THE HEMLOCK

DRB Recommendation Meeting
December 16, 2019
SDCI # 3033219

WH GREENWOOD, LLC

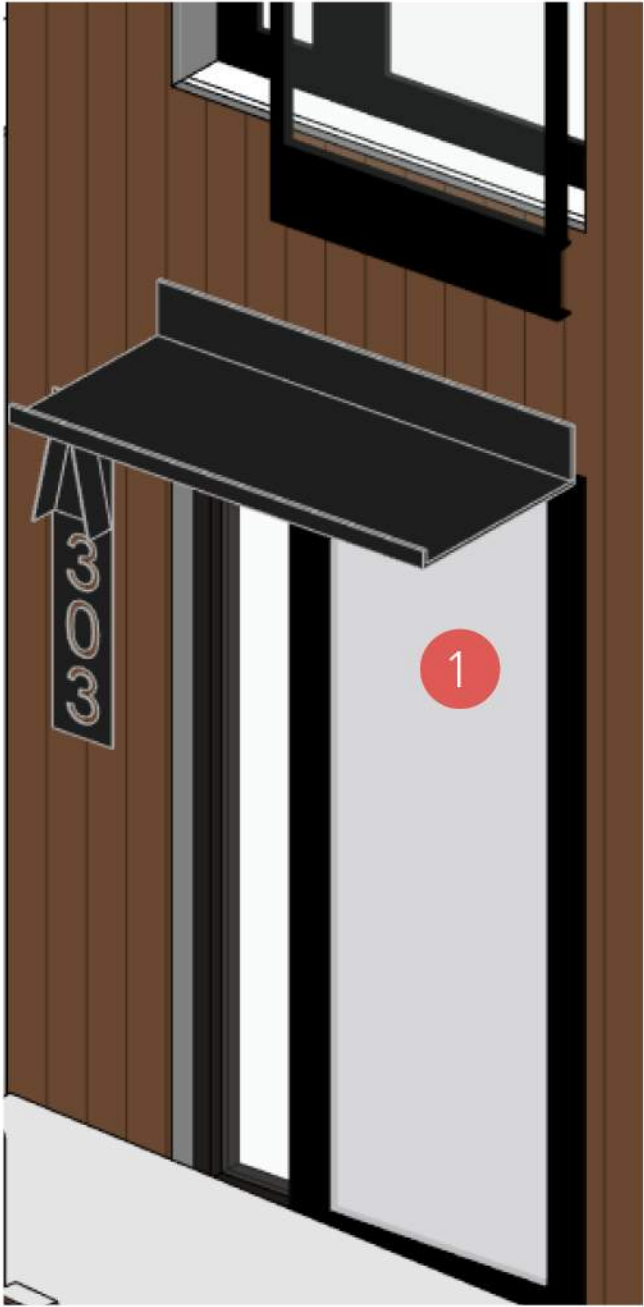
1d. While not supporting its architectural character, the Board identified the east side of Phinney as setting important precedents, where a variety in height, depth and width create an assembly of small, medium and large elements. CS2-D-1, CS2-II-ii.

Response:
The combination of the overall massing, the new serrated bays, the "bookend" metal-clad bay at the North end of Phinney, and additional curves at each of the ground-related stoops create a similar assembly of small, medium and large elements as the context across the street on Phinney.

The Greenwood/Phinney Design Guidelines give clear guidance on facade articulation (DC2.I). The proposed Phinney massing employs 3 of the 4 suggestions to "add further interest to a building, and lend buildings a human scale:

The proposed stoops are recessed at each serrated bay with weather protection at the unit entry doors.

Vertically proportioned windows are proposed at all residential units.

A custom-pattern board and batten cladding which incorporates a specially-detailed window jamb trim is proposed at the serrated bays. Similar detailing can be found at the courtyard facades.

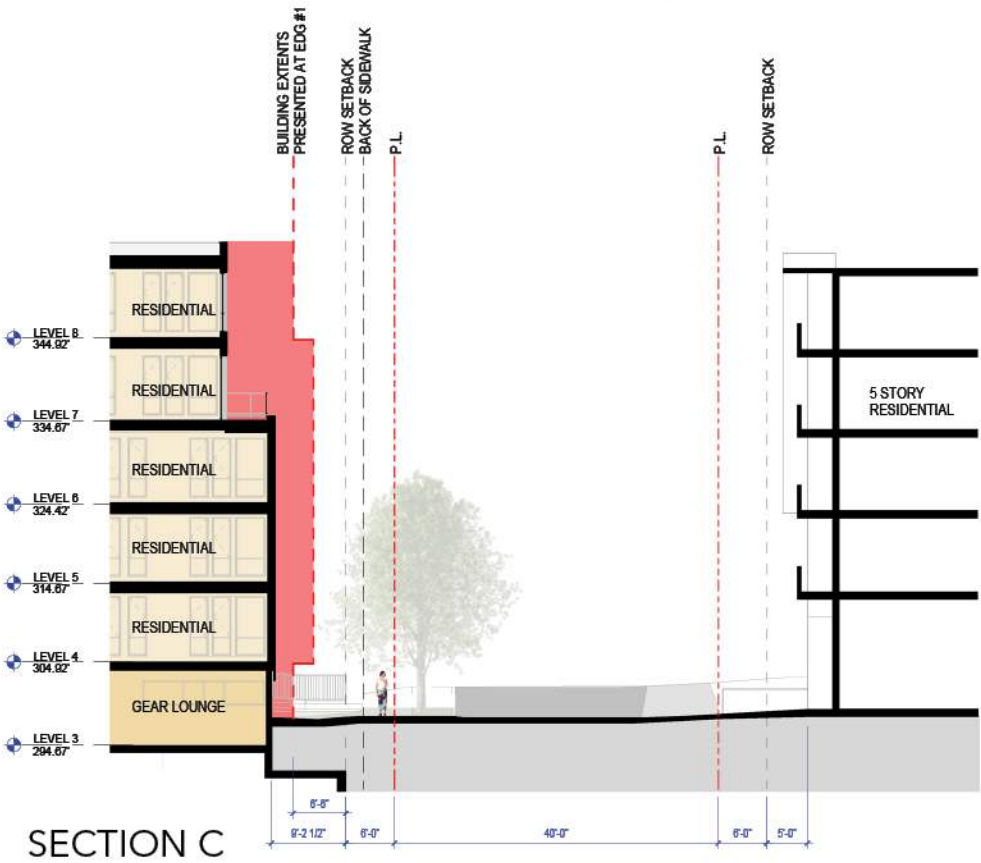
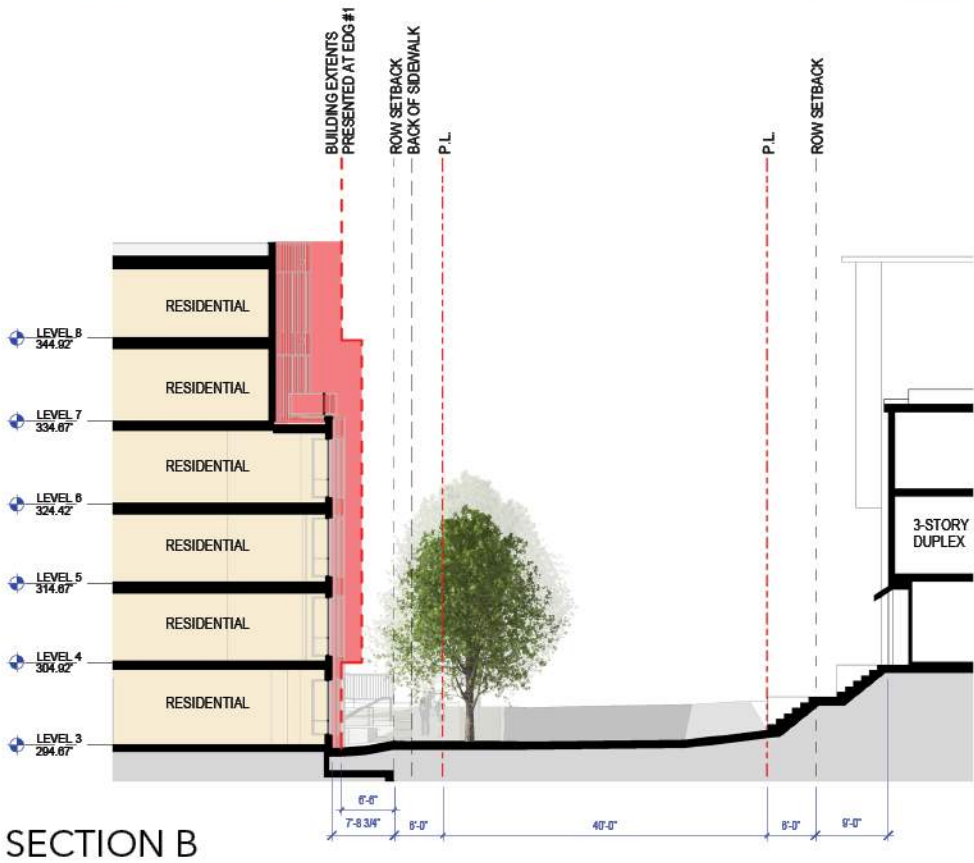
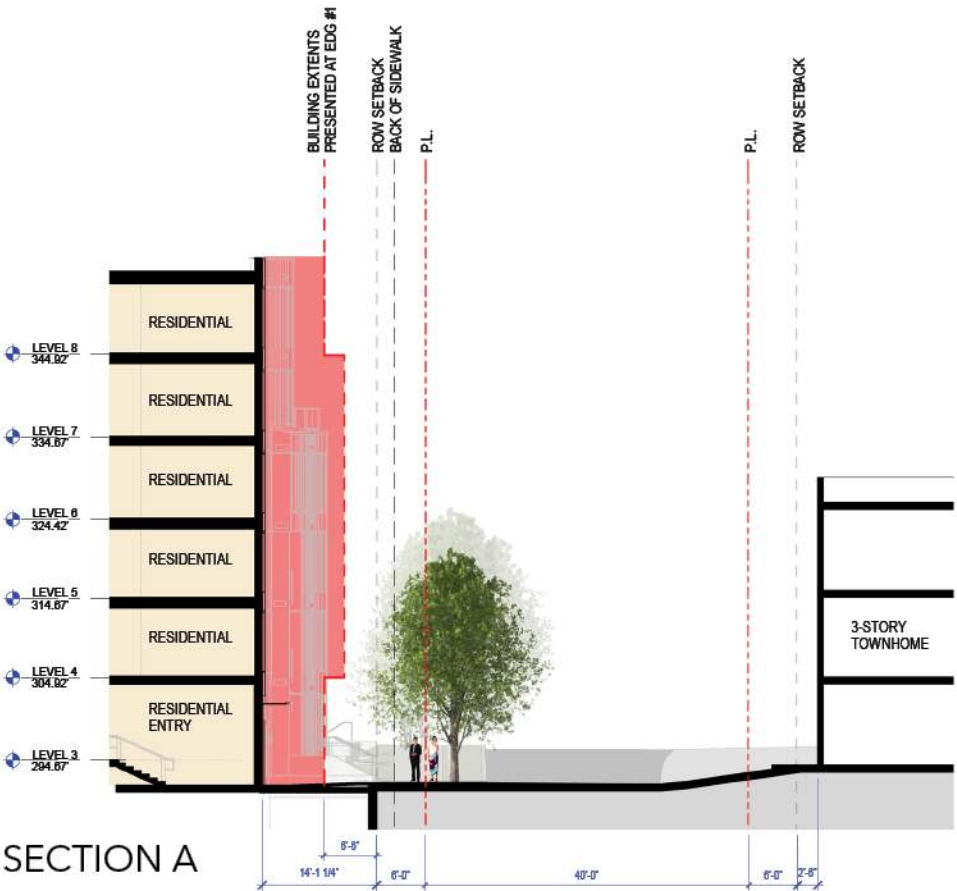
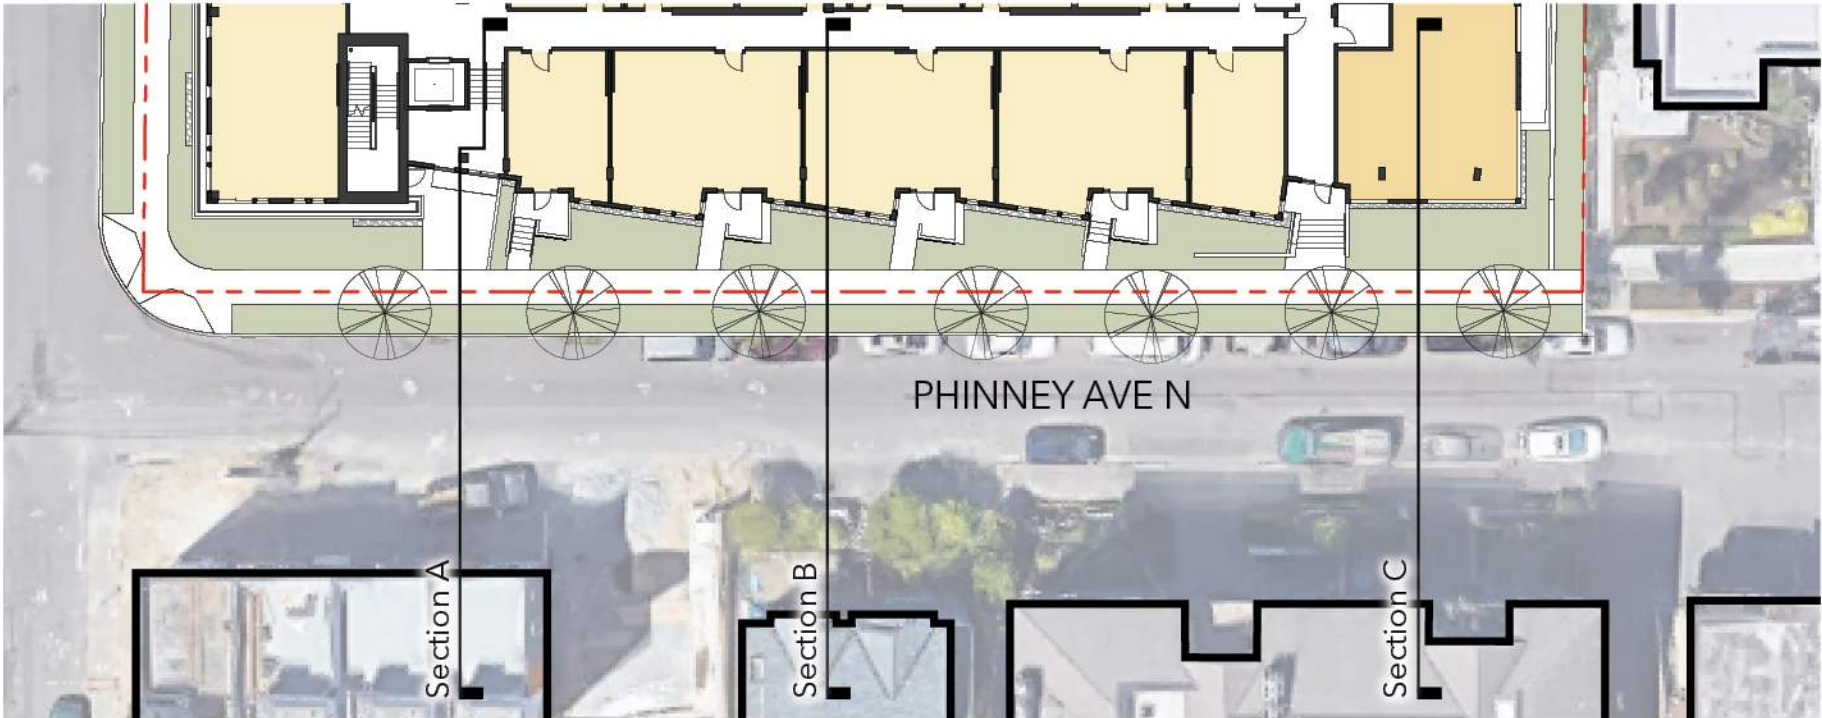
1f. The Board noted that a response to the grade change along Phinney could generate massing shifts that would help mitigate the bulk and scale issues at this edge. (CS2-D-2, CS2-B)

A variety of stoop conditions resulted in order to ensure accessible entry to the ground-related units. Although the concept of stepping the building with the grade along Phinney intrigued us, we found this would be at odds with the Design Guidelines' recommendations for zone transition mitigation as the grade naturally slopes up to the north and less-dense zone.

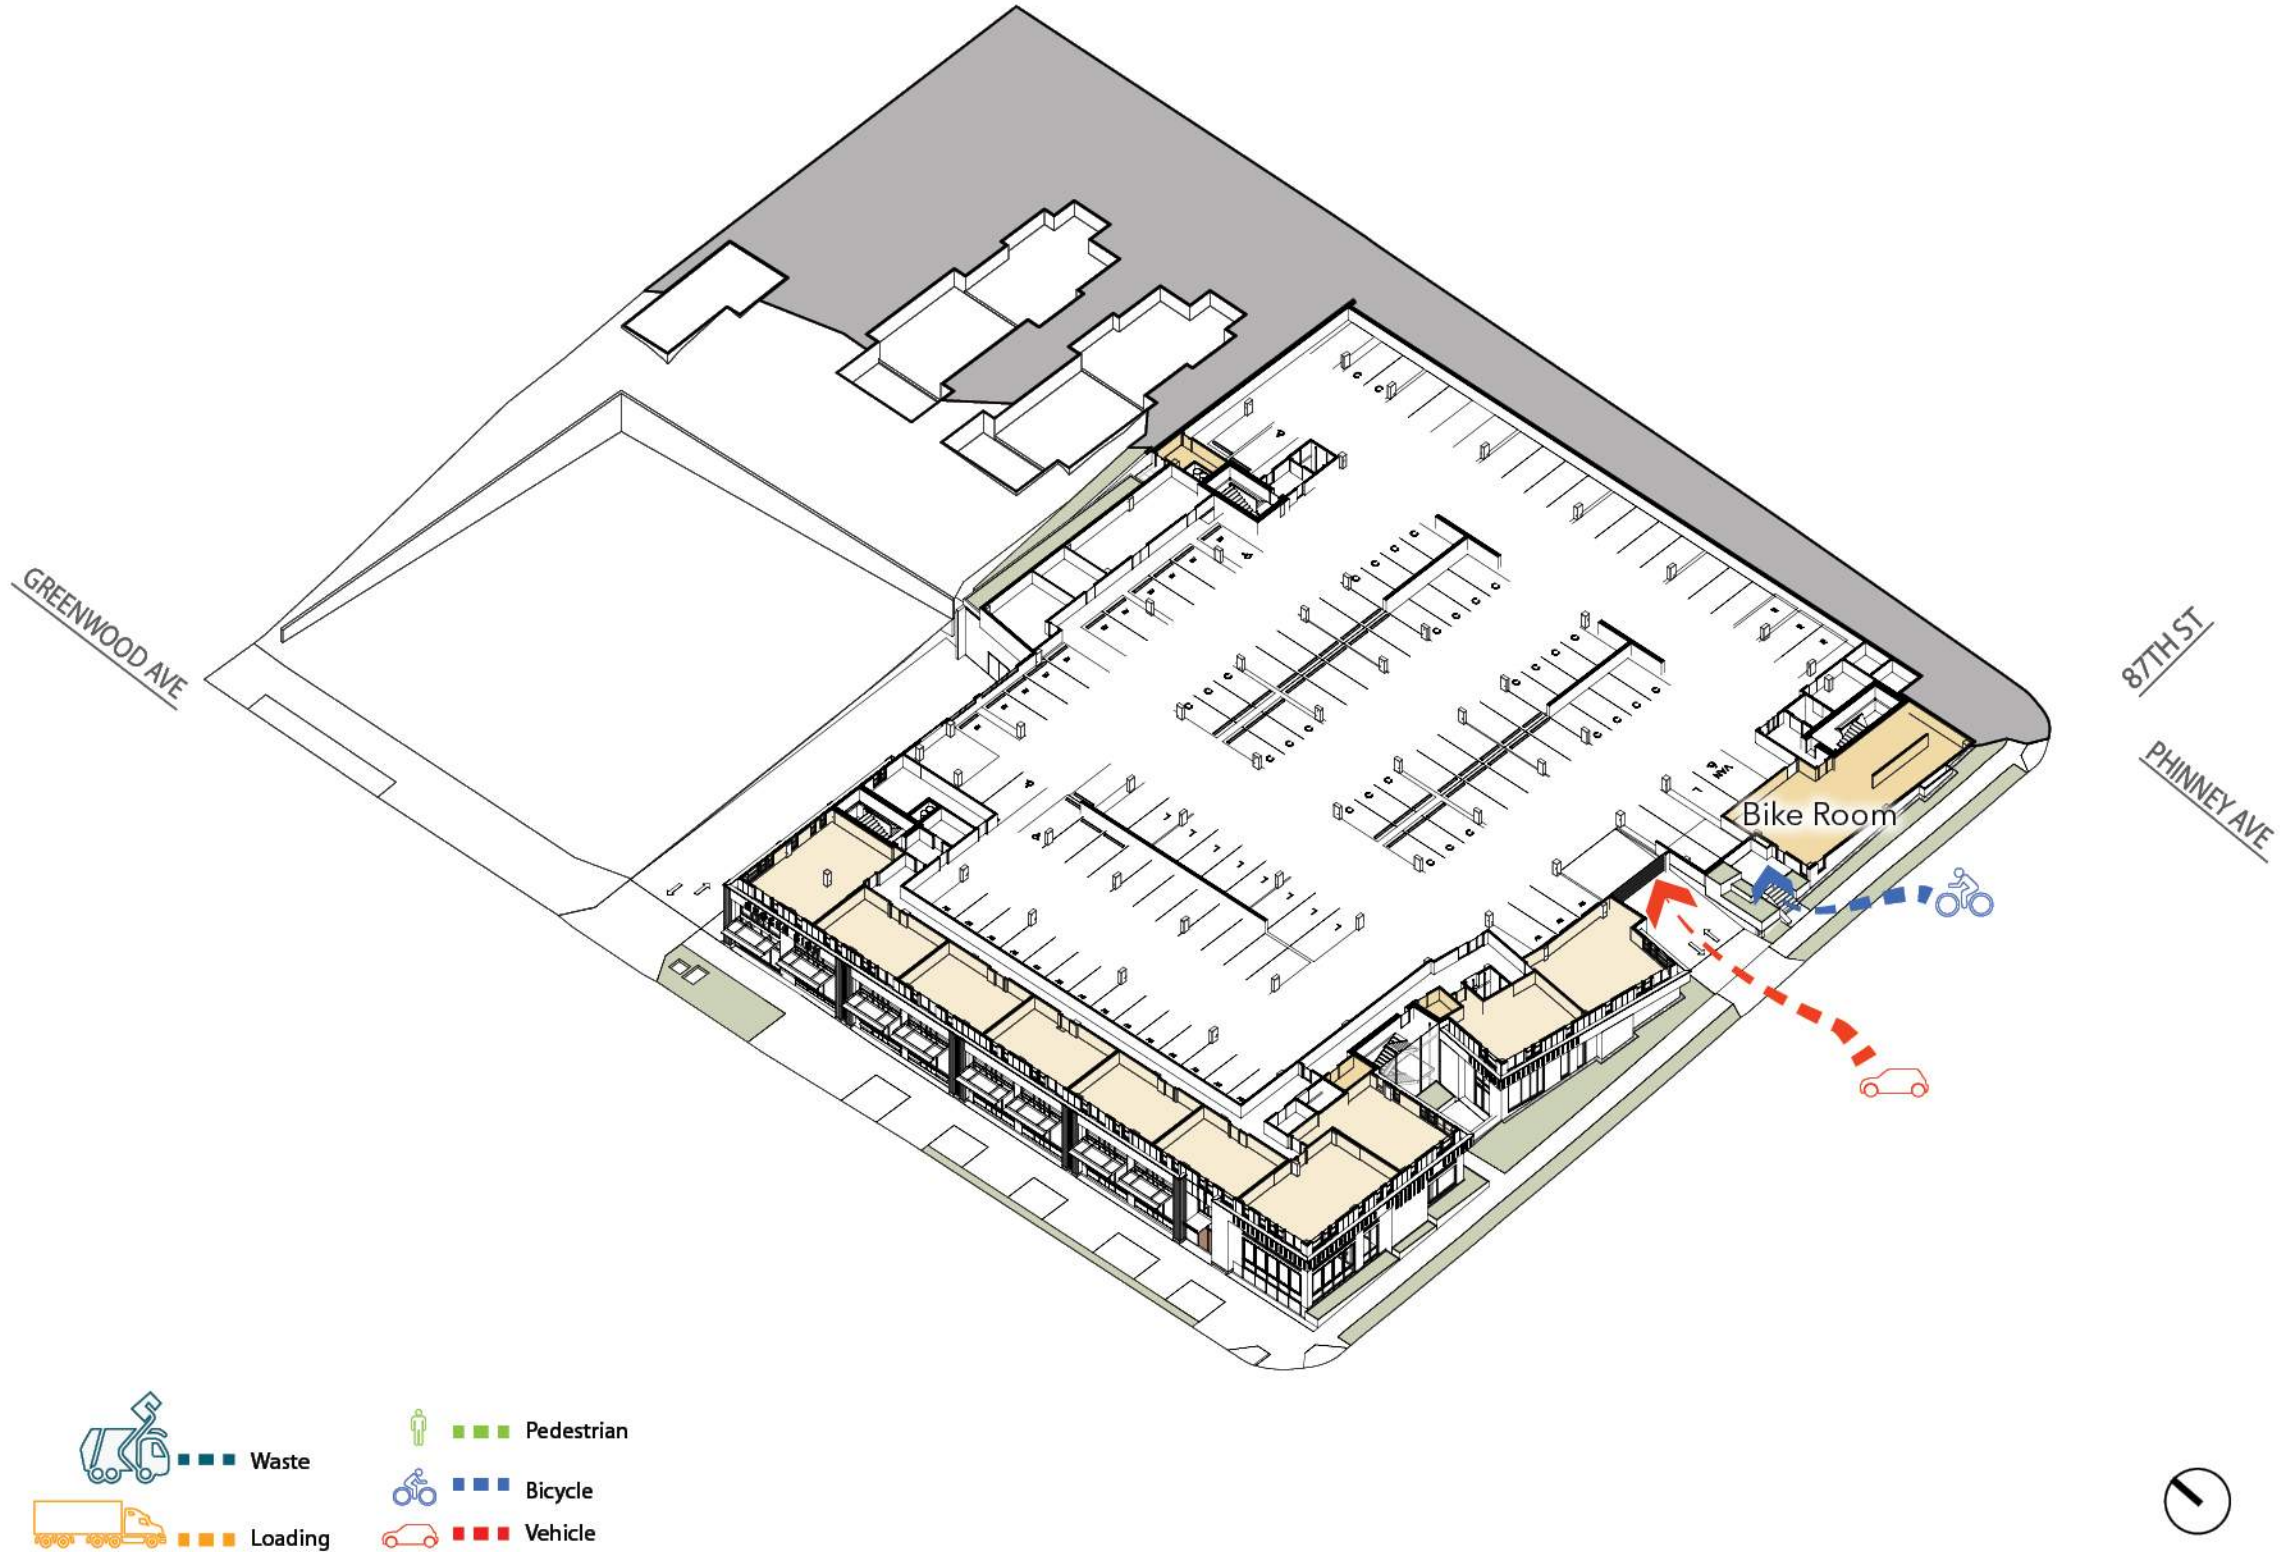
2a. The Board offered their particular support for the squaring of the center bar, the connection to grade and transparency of the western stair and the human scale elements added to the street edge. (DC2, DC2-II, CS2-I)

Response: These elements of the design have been retained.

N. 87TH STREET ELEVATION

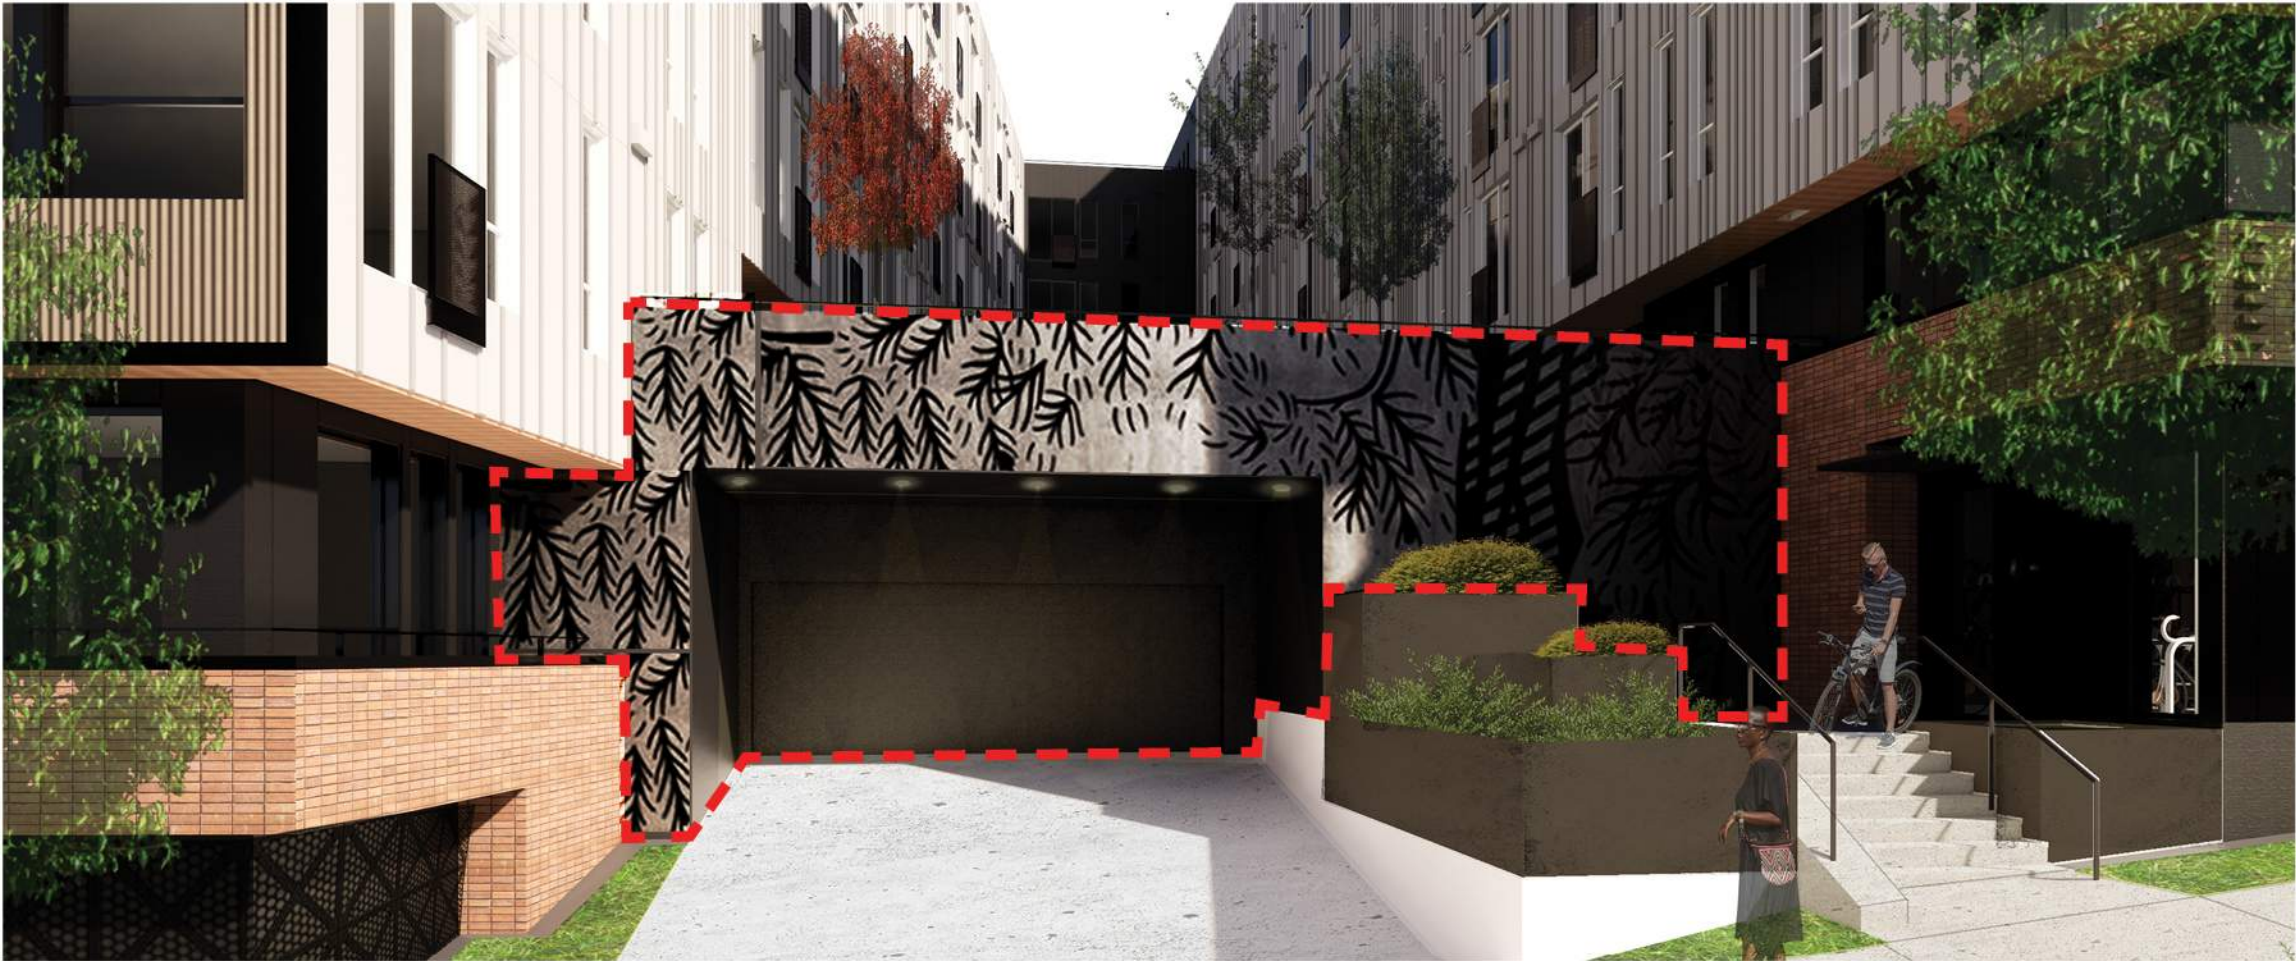
3d. The Board supported the incorporation of art into the project but agreed that it currently appeared tacked-on and gave guidance that its location and expression be clearly tied to the design concept and have an understandable order. (DC1-I, DC2-B)

Response:
The team revised the concept for art integration, focusing primarily on the garage entry wall. The Greenwood/Phinney Design Guidelines (DC1.II.ii) suggests,

We have created other opportunities to tie the garage entry art in with the building signage at the residential entry and Phinney stoops.
